Kao et al.
Application No.: 09/256,265
Page 10

REMARKS

59
Fig. 3d

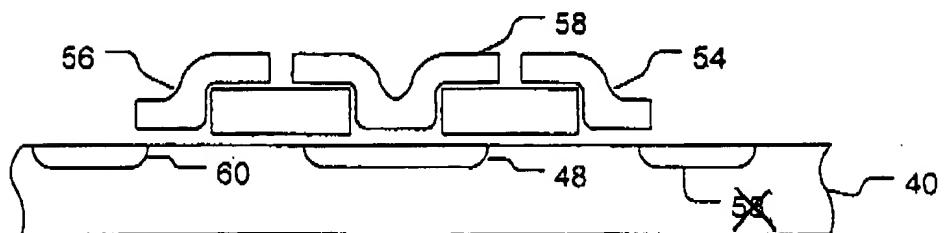
In Fig. 3d, drain region 59 was inadvertently referred to as 58. The first paragraph on page 8 has been amended to refer to drain 59.

In Fig. 3d, drain region 59 was inadvertently mislabeled 58. It has been corrected to 59. A marked up sheet for sheet #2, which includes the proposed changes to Fig. 3d, is submitted as part of this amendment for the Examiner's review.
